Blue Ridge Environmental Defense League

April 19, 2013

**RE: William S. Lee III Nuclear Station
Notice No. 13-031-H/March 4, 2013
Permit No. SC0049140**

Conceptual: Existing ponds A/B and proposed pond C will be interconnected to provide cooling water when flow in the Broad River is too low to use.

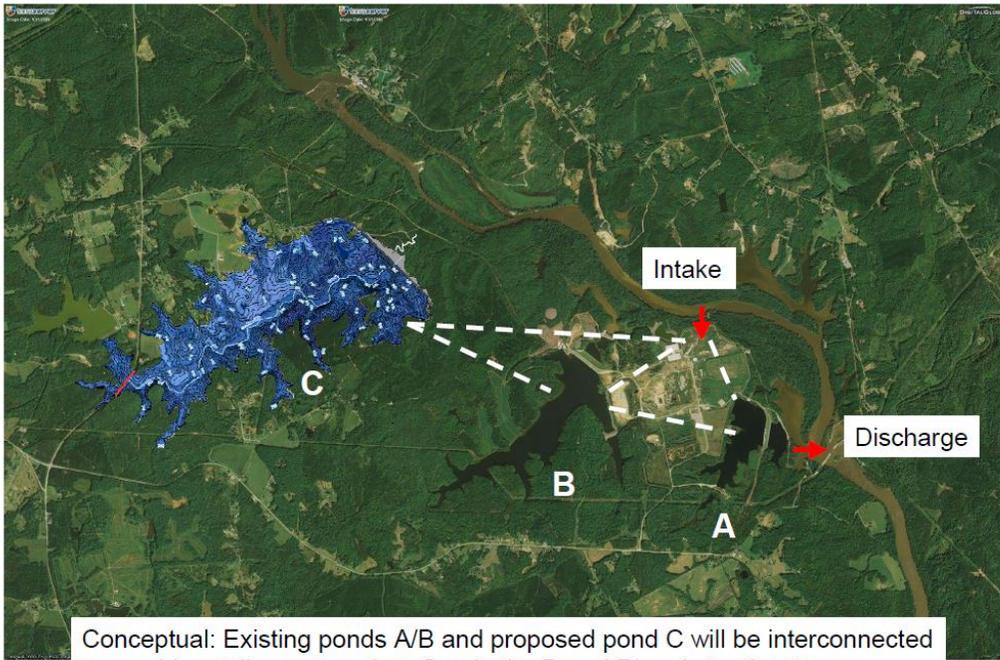
The waste heat is discharged into the air via a cooling tower or to surface water by a pipe. Duke Energy plans to use mechanical draft wet cooling towers at the Lee Station. For cooling purposes, the Lee station would require the withdrawal of 35,030 gallons/minute from the Broad River. Of this, 71% would be consumptive use, water lost by evaporation and drift loss from the cooling towers. The remaining 29% would be returned to the river as heated water.³ As illustrated in the map and table below, the discharge to the river would be at the Ninety-Nine Islands Dam.
